S.S. PAPADOPULOS & ASSOCIATES, INC.
ENVIRONMENTAL & WATER-RESOURCE CONSULTANTS

December 16, 2020

Subject: Initial review comments on the hydrologic and hydrogeologic analyses for the impact assessment of the proposed Burlington Quarry Extension

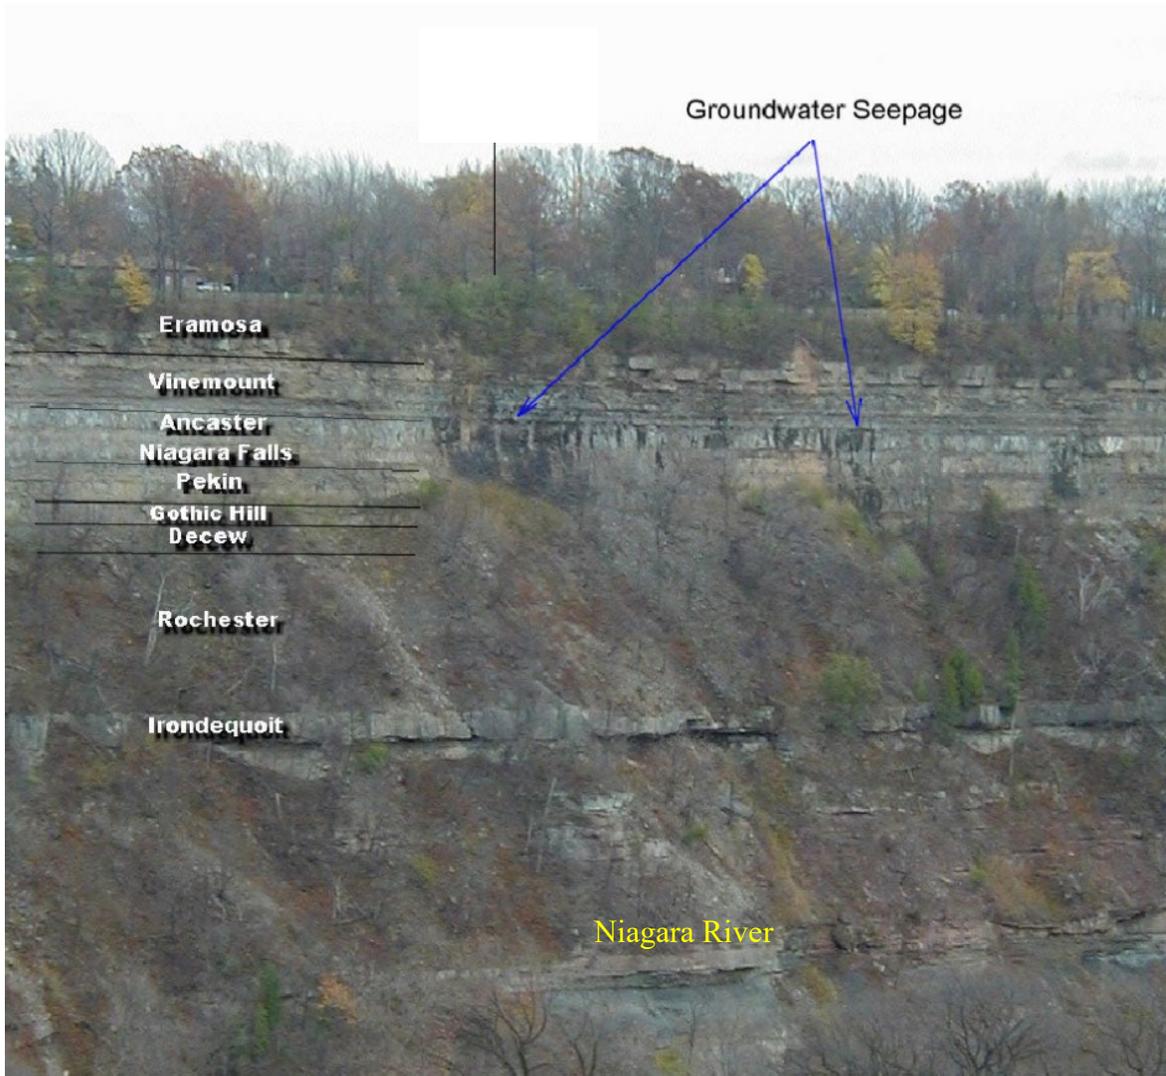
6. It is indicated on page 92 that the layers of the MODFLOW and GSFLOW models must be continuous across the model domain. This requirement has been interpreted in a way that we consider to be non-physical. The results close to the deep cutting features, including the Medad Valley and the existing quarry are not realistic. An excerpt from a cross-section through the model along 2nd Side Road is reproduced below (Figure 5.2). As shown in the figure, the model layers are “pushed down” below the base of the Medad Valley.

In our experience, this is not a realistic representation of the bedrock flow zones in the rocks of the Niagara Escarpment. For example, a view across the gorge of the Niagara River downstream from Niagara Falls is shown on the next page. Rather than diving down below the Niagara River, the bedrock flow zones daylight at the gorge. Groundwater exits at the base of each flow zone, forming stacked seepage faces.

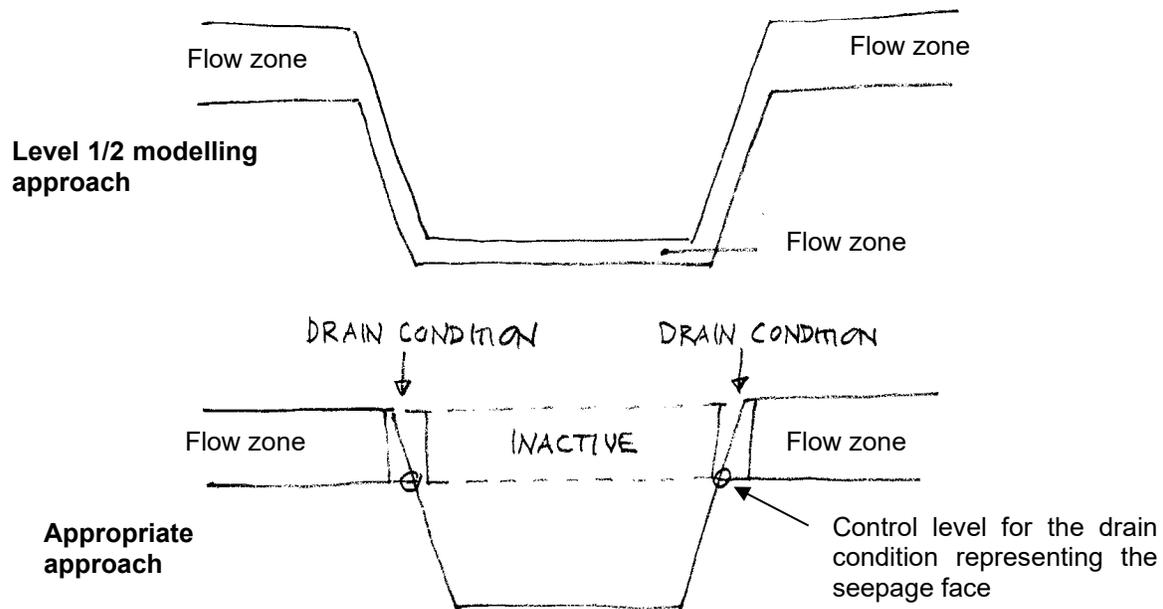
A physically realistic approach for representing this situation is shown schematically below.

Figure 19.22: Comparison of observed and simulated water levels at monitor OW03-15.

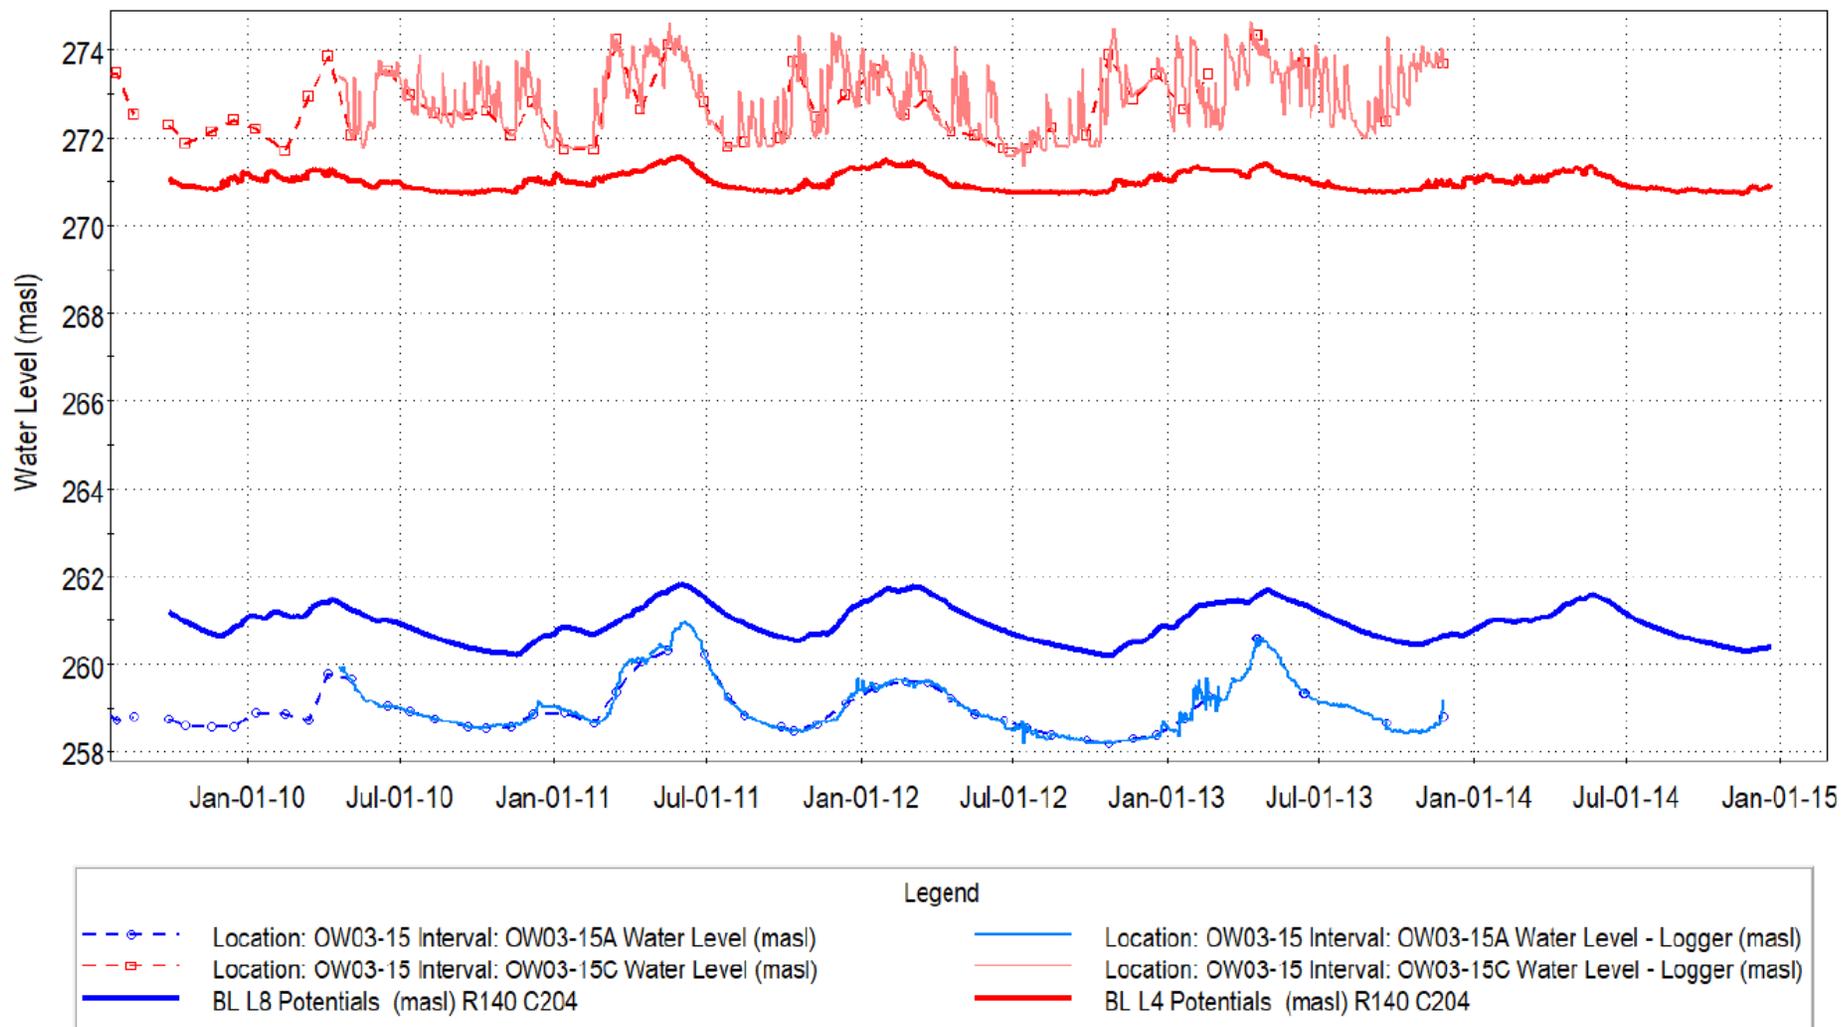
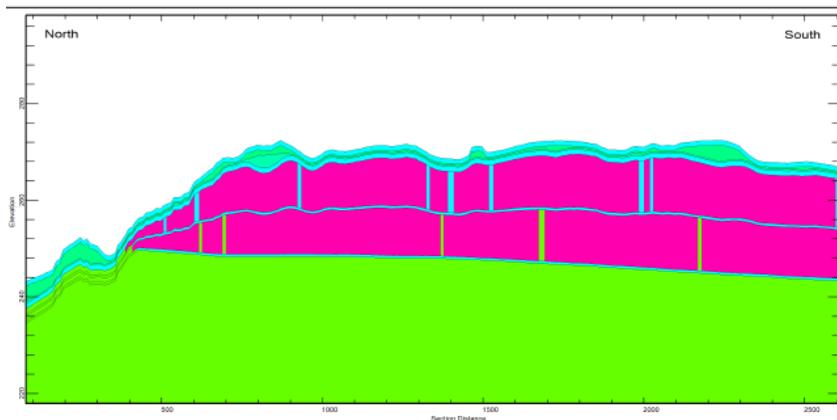
The results shown in Figures 5.2-5.4 and 19.18-19.20 of the report illustrate why the representation of conditions along the Medad Valley and Niagara Escarpment and around the existing quarry is important. A portion of Figure 19.18 is reproduced below. There is no evidence to suggest that the water levels in the weathered top-of-rock and in the middle flow zone decline steeply as predicted with the model. Hydrographs for observation well OW03-15 between April 2003 and July 2010 and between July 2009 and January 2015 are reproduced here on page 9. The long-term average water levels in the shallow "C" and deeper "B" and "A" monitoring intervals are about 273 m, 269 m and 259 m amsl, respectively. Since 2003, the water levels have varied by only about ± 1 m with respect to the average levels. The water levels are controlled by the elevations at which the flow zones daylight at the quarry, indicated by the circles added to the excerpt from Figure 19.18. In our opinion, the non-physical simulation approach that has been adopted compromises severely the reliability of predictions of potential impacts of the quarry extension.

Regional faulting in southern Ontario (from Mazurek, 2004)

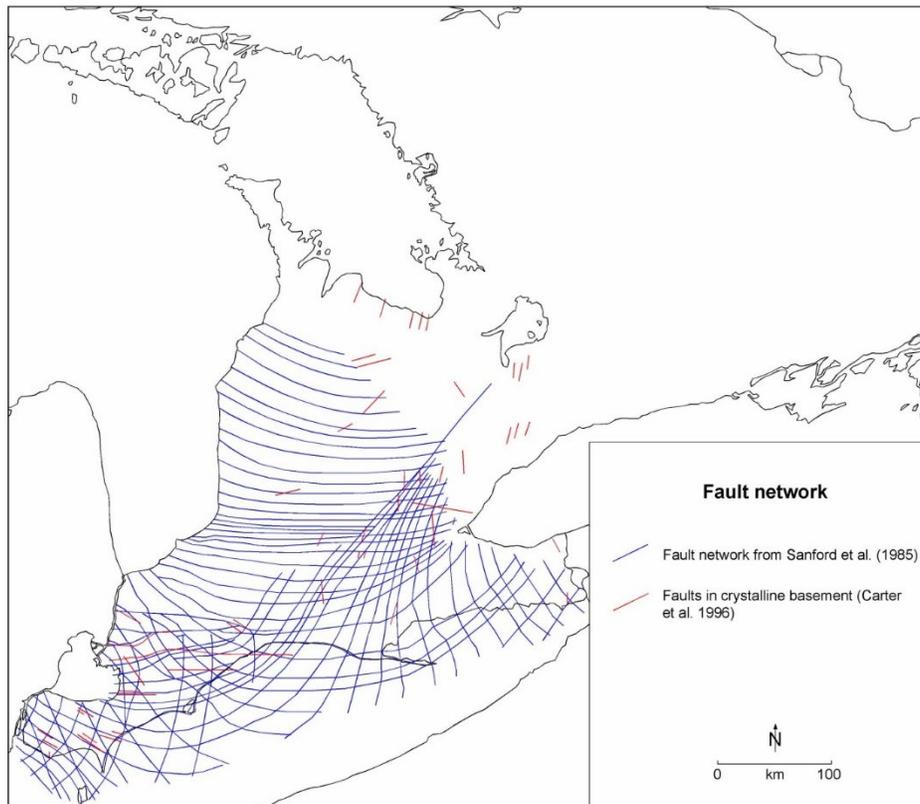
There are no data to constrain the assumed distribution or properties of the chimneys. At a minimum, we would expect the fractures to follow the jointing patterns in the underlying rock. As shown below, the distribution of the chimneys bears no relation to regional joint patterns interpreted by Mazurek (2004) [based on the work of Sanford et al. (1985) and Carter et al. (1996)].

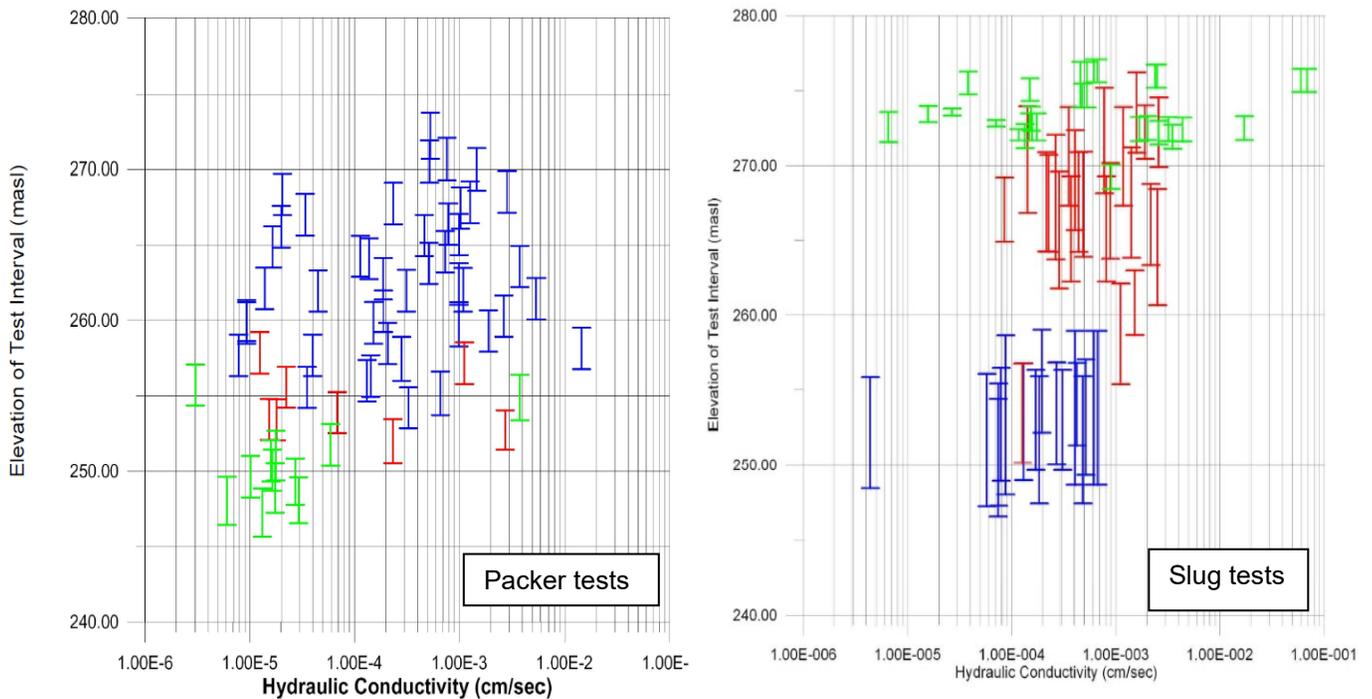
8. Although the model has been developed to predict the potential impacts of the quarry expansion, the predictive capacity of the model has not been demonstrated. In general, the hydrographs presented in the report demonstrate that the model is capable of reproducing changes in water levels that are driven by seasonal variations in climate. However, no comparison is presented between observed and simulated average declines in water levels caused by the quarry operations. The quarry has been operating sufficiently long that it should be possible to identify the declines for at least some key monitoring locations. An appropriate application of the MODFLOW model would be to simulate time-averaged water levels for different positions of the quarry face. Did the position of the quarry face change 2003/2004 and 2007/2010? Has the position of the quarry face changed between 2010 and 2020? The results of time-averaged simulations of the different time periods would be important for confirming that the predicted effects of the quarry expansion on bedrock groundwater levels are within the realm of possibility.

Referring the hydrographs in Golder (2010), we estimate that for OW03-14A, the average level between April 2003 and July 2004 was about 272 m amsl, and between July 2007 and July 2010 the average level was about 261 m amsl. For monitoring well OW03-15A, the average level between April 2003 and July 2004 was about 260 m amsl, while the average level between July 2007 and July 2010 was about 259 m amsl. Substantial drawdowns were also observed at OW03-21. Golder (2010) present hydrographs for three other wells that show clear long-term declining trends and that might be used for this demonstration: Onsite quarry well 5 (Golder, 2010; Figure D.1.77); Onsite quarry well Goodchild (Golder, 2010; Figure D.1.78); and Onsite quarry well Sterrett (Golder, 2010; Figure D.1.79).

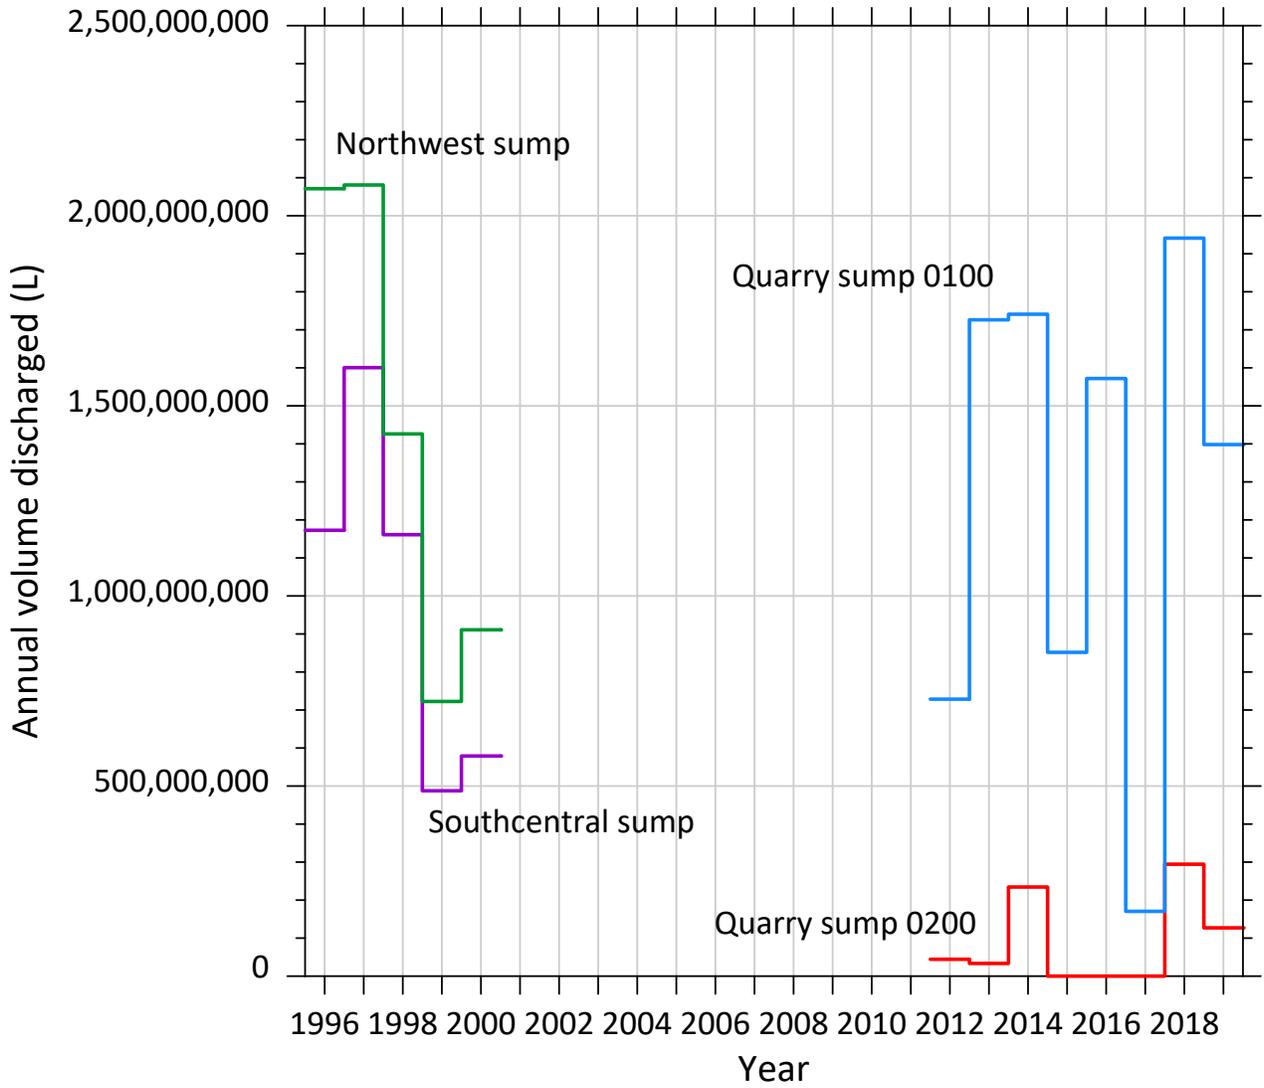
11. A key result for any model calibration is the match to observed groundwater discharges. Our understanding is that the North Quarry discharge corresponds to the flows measured at SW1, and that the final model results are compared against the observations in Figure 19.10. Why is the discharge shown for only 5 years? Our impression is that the model results do not approximate the observations. We further understand that the South Quarry discharge corresponds to the flows measured at SW6, and that the final model results are compared against the observations in Figure 19.11? Why is the discharge shown for only 7 years? Our impression is that again the model results do not approximate the observations.

The annual quarry discharges from 2012-2019 are listed in Tatham (2020; Table 1). In the following figure the values reported by Tatham are supplemented with sump pump between 1996 and 2003 (Golder, 2010; Table E-8). Our impression is that there have been important variations in the quarry discharges. How have these variations been considered in the analyses?

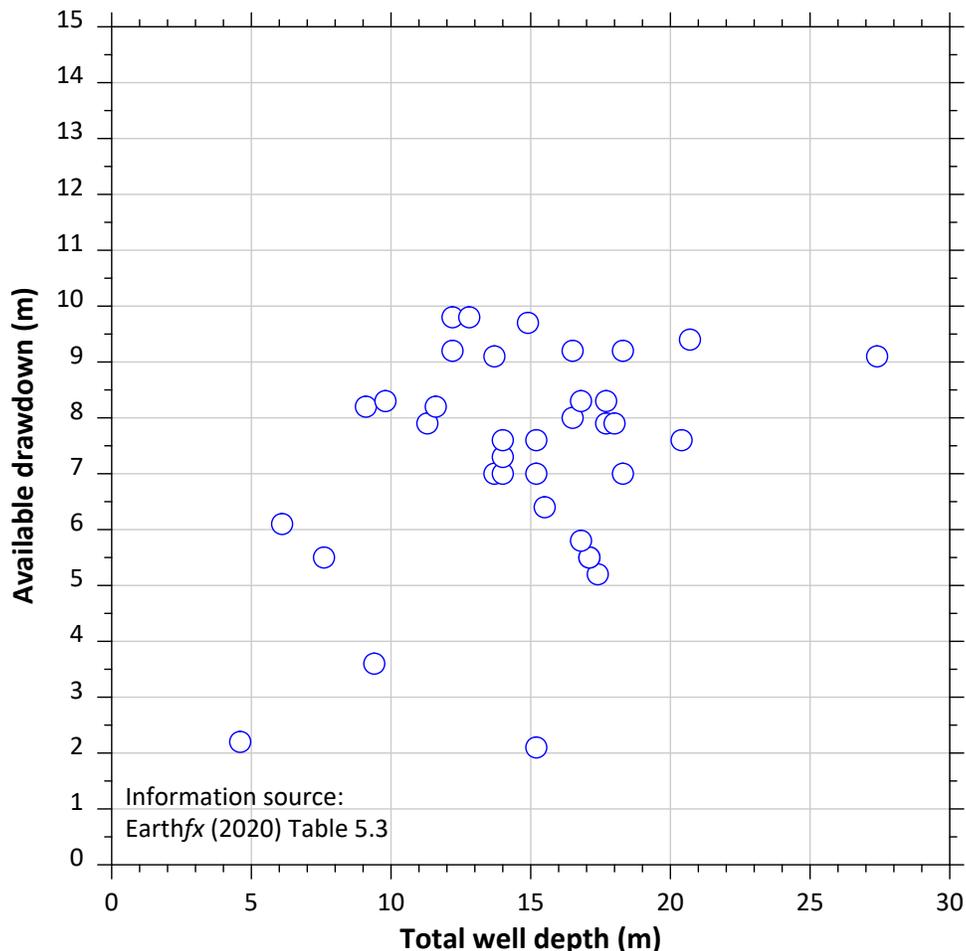
15. The next-to-last paragraph on page 167 of the Earthfx report reads:

Figure 7.3 presents a summary of the groundwater supply conditions in the study area. This figure shows the available groundwater drawdown in the Amabel Formation. At any location in the vicinity of the quarry a private water well could be drilled to the Layer 8 fracture zone and would have up to 22 m of available drawdown. Near the existing quarry that drawdown is reduced by the effects of the quarry dewatering, but many wells are both shallow, and in close proximity to the quarry, and yet have had suitable water supply for many years.

It is not clear why model Layer 8 [Amabel Lower Fracture Zone] has been selected for the assessment of the available drawdown for baseline conditions. The depths of private wells within 500 m of the extraction boundary are reported on Table 5.3 of the Earthfx report. As shown in the plot of these data below, it is likely that private wells extend only into the weathered top of rock (model Layer 4) or model Layer 6 [Amabel Middle Fracture Zone].

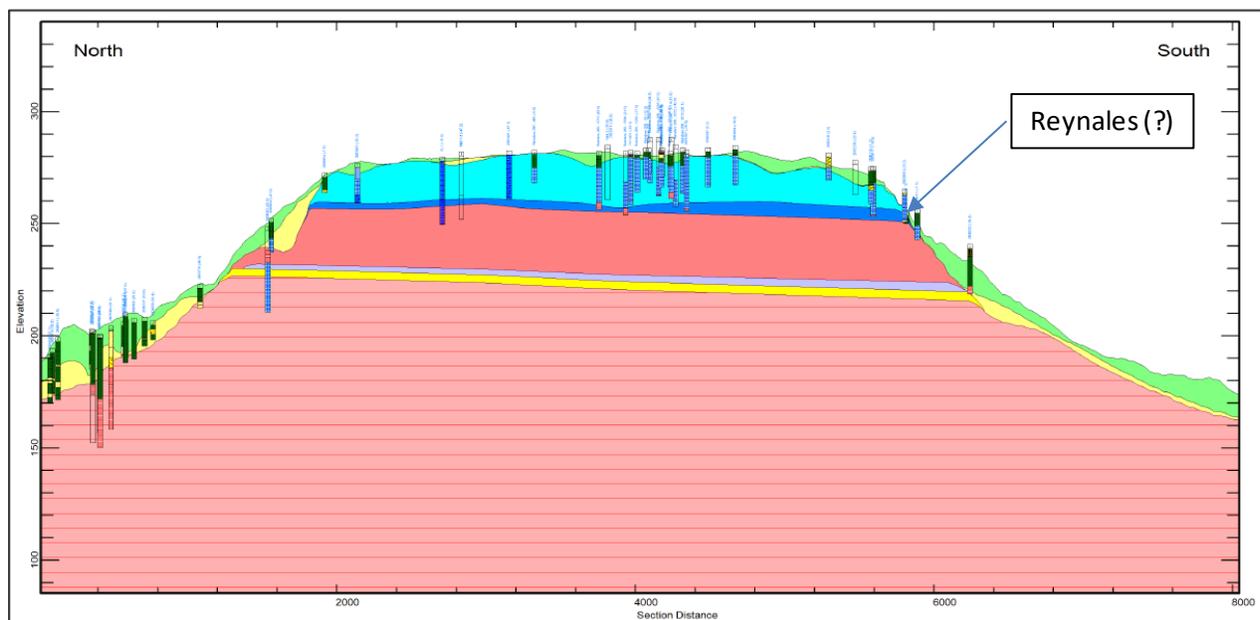
Figure 7.3 shows a map of calculated values derived from two other maps of calculated values that are not provided. It appears that what is shown is the difference between (1) the simulated average water level in Layer 8 of the model (Lower Fracture Zone) for the period of WY2010-WY2019, and (2) the assumed elevation of the top of Layer 8. It is not possible to assess the reliability of this figure with the information provided in the report. As far as we are aware, no map of simulated water levels in Layer 8 is included in the report. Our interpretation of the time period may not be correct. The description of Figure 7.17 in the preceding paragraph refers to a time period of WY2015-WY2019. We could also be wrong about the assumed elevation for calculating the available drawdown. It might be the middle or the bottom of Layer 8. We have not been able to find the reporting of the thickness for layer 8. It is described as 'representing a thin lower fracture zone' (page 481 second last paragraph).

More important than simply checking the reliability of the calculation of the values of the available drawdown shown in Figure 7.3, it is not possible to assess the reliability of the simulated groundwater levels used in the calculations. In Figures 18.3 and 19.3, simulated average water levels are compared with water levels reported in the well records for the private wells beyond the site boundary. The results shown in these two figures suggest that the likely mismatch at the location of an individual well is relatively large, on the order of ± 10 m.
